ENTRANCE STEPS	ROYAL FREE PEARS BUILDING
PLANNING	1372-GA-104-08

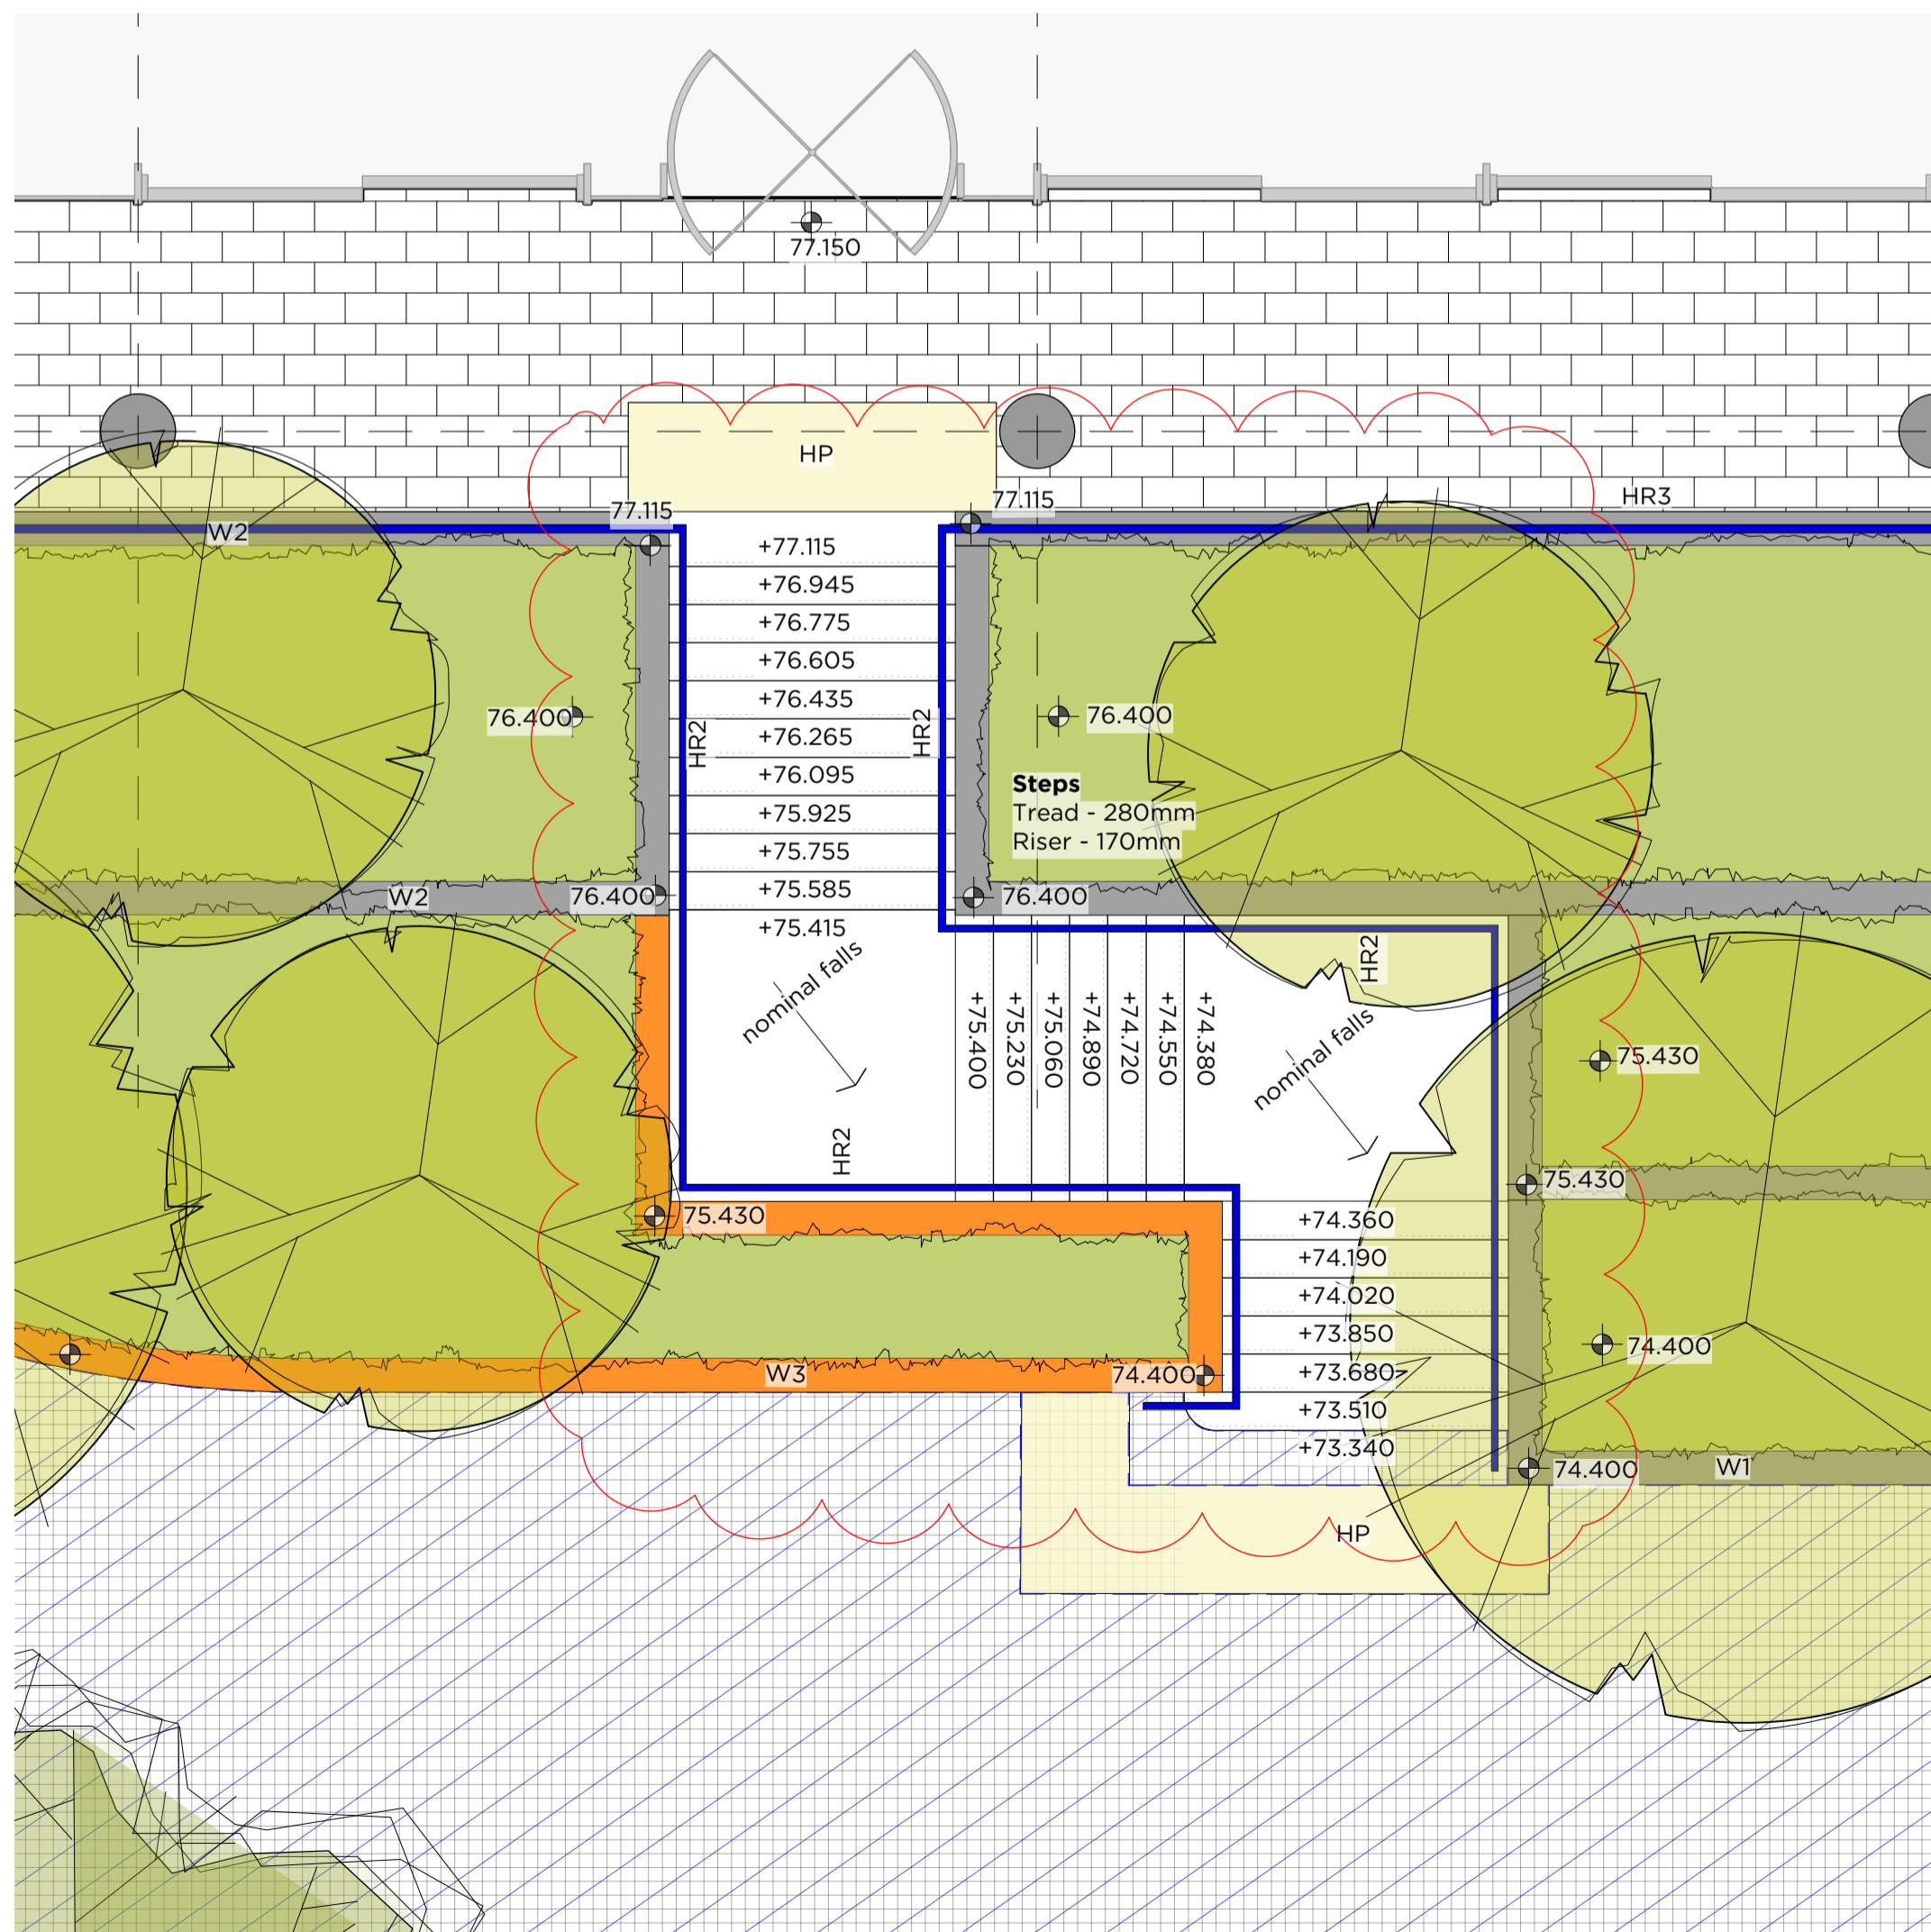
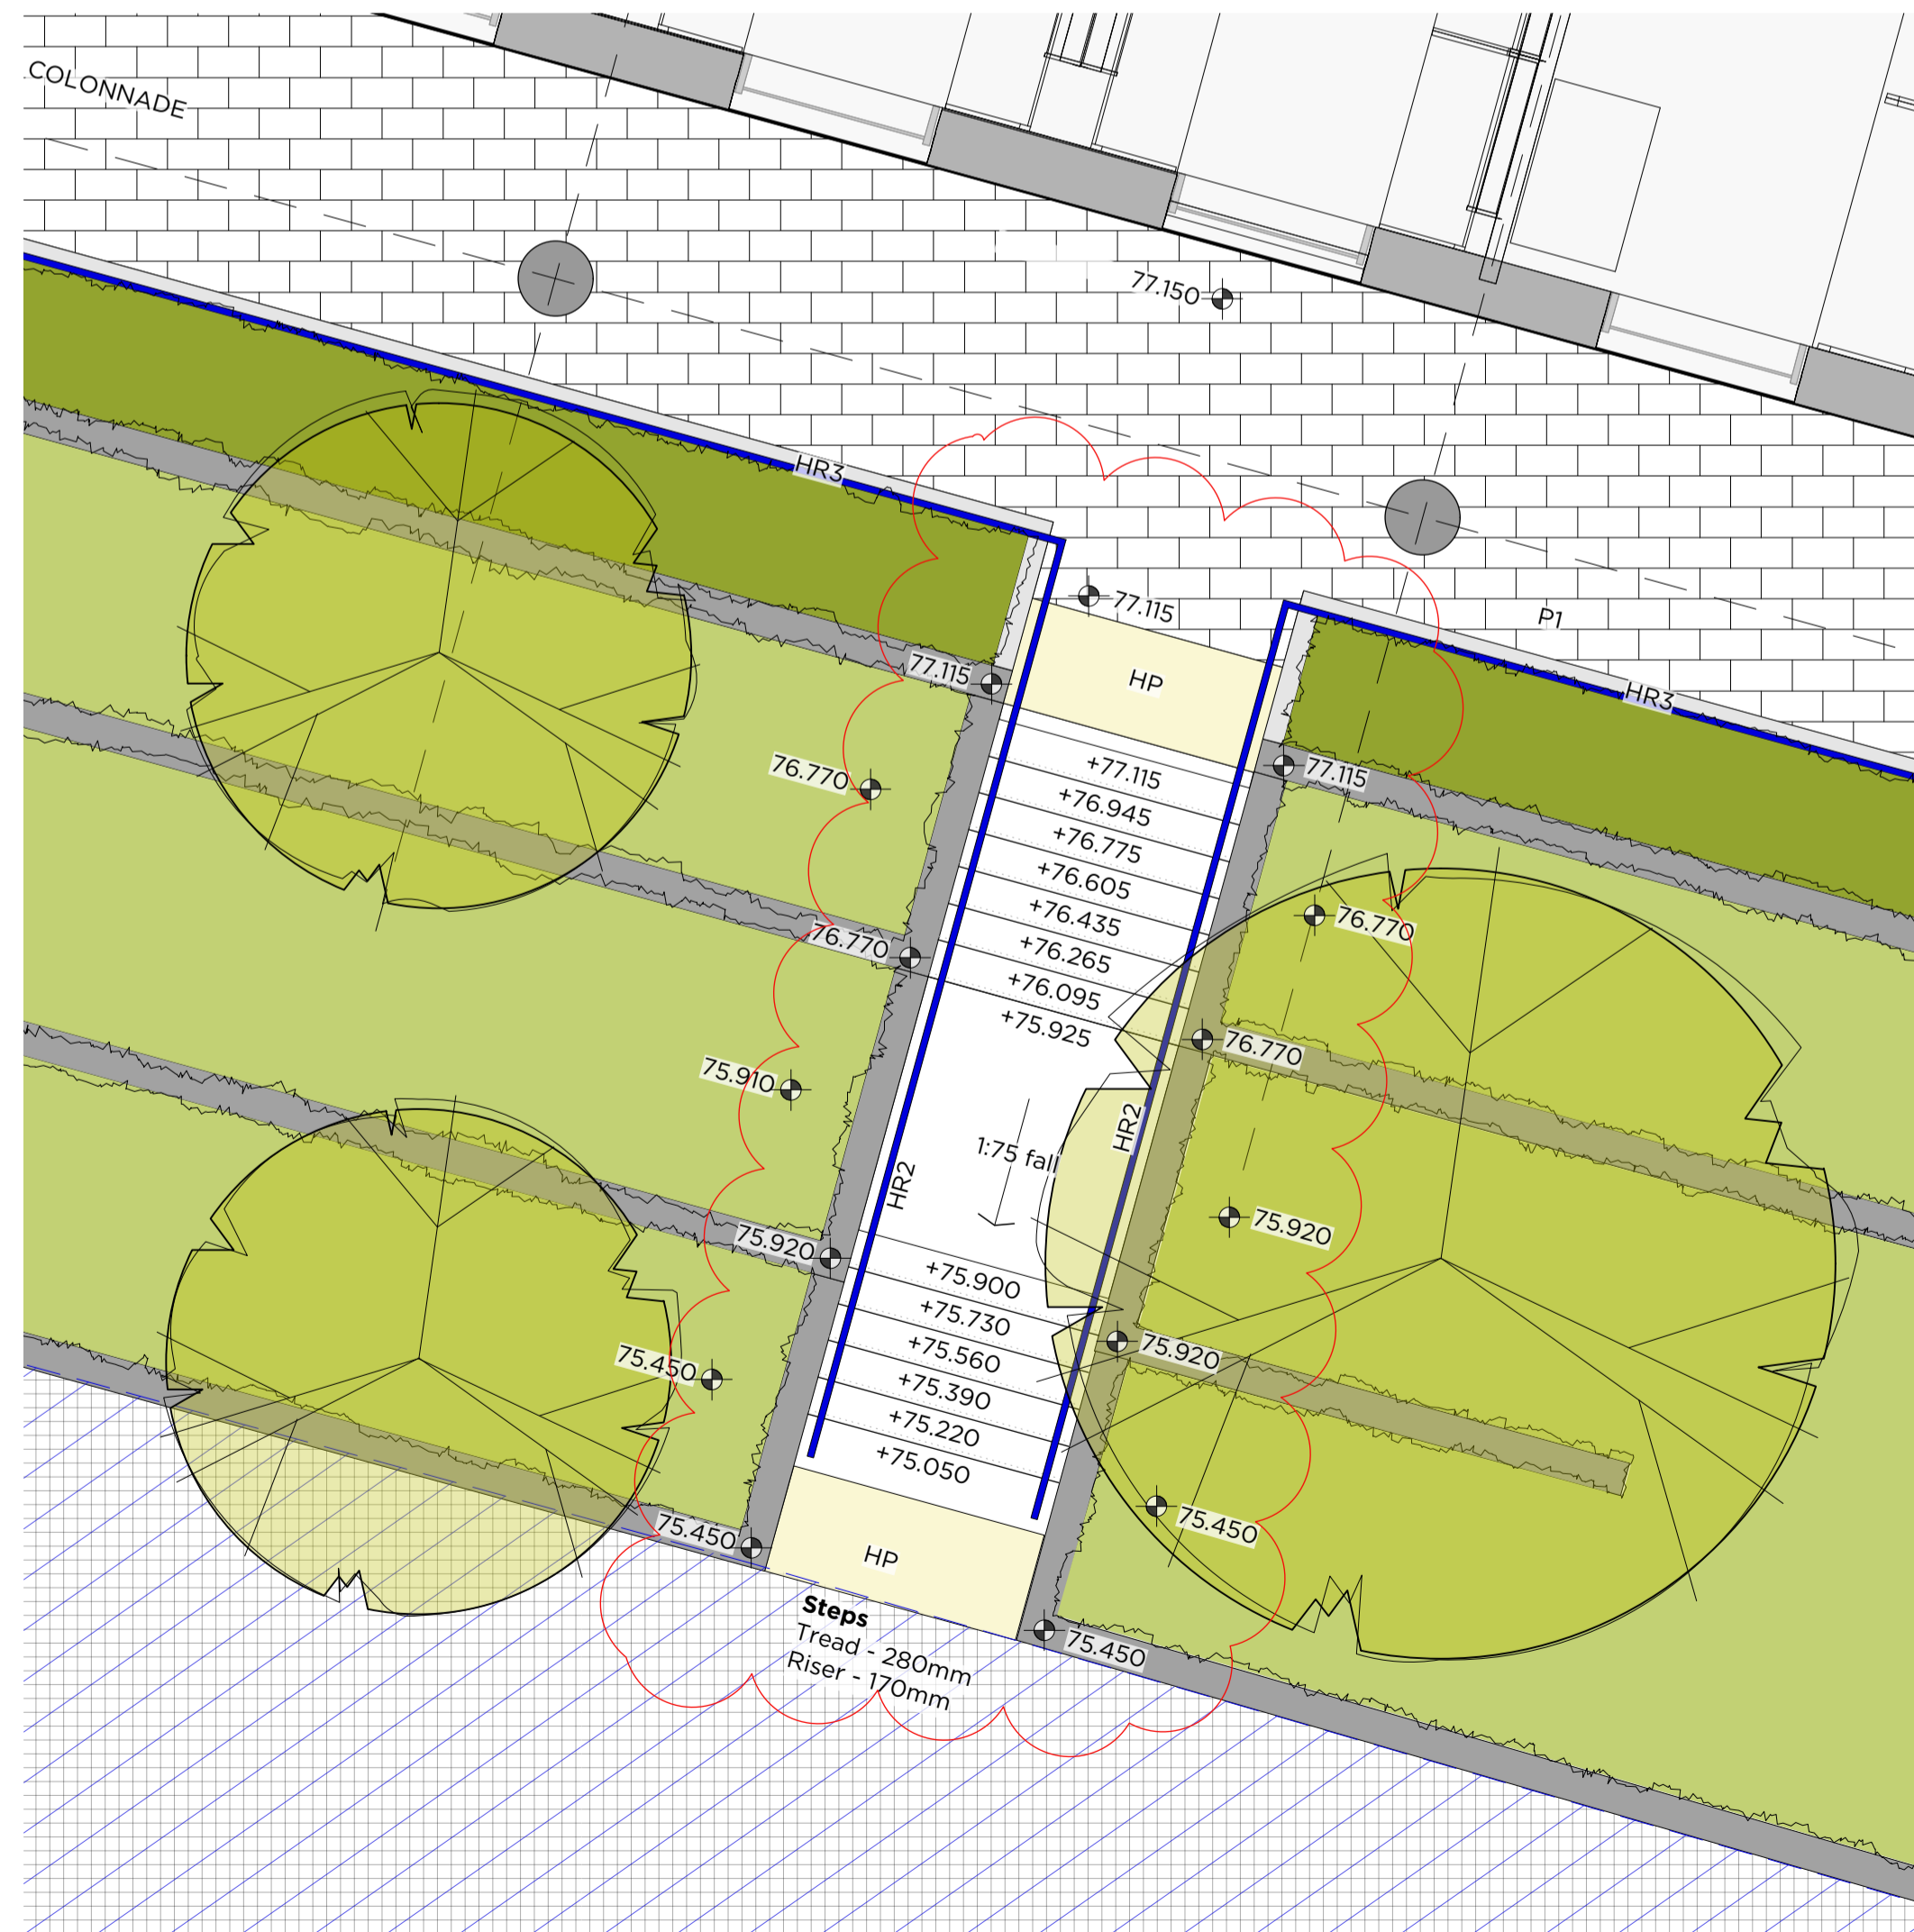
Note: Entrance steps and surrounding terraces / retaining walls and landscaping have been revised in accordance with Non Material Amendments application / Reference: 2017/4229/P

08	Revised layout. Lighting omitted.	06.10.17	KI	General notes:
07	Drawing updates	25.07.16	MS	1. This drawing is to be read in conjunction with other C&M landscape drawings and specifications.
06	Further Hopkins Comments added	18.07.16	MS	2. Any discrepancies between sources of information should be immediately notified to the Landscape Architect for clarification.
05	Revised following Hopkins	05.05.16	CP	3. Do not scale off this drawing.
04	Revised Layout for Planning	25.04.16	CP	4. All dimensions in mm unless otherwise stated.
03	Revised Layout	23.03.16	CP	
02	Revised Layout	10.03.16	CP	
01	Revised Layout	26.02.16	CP
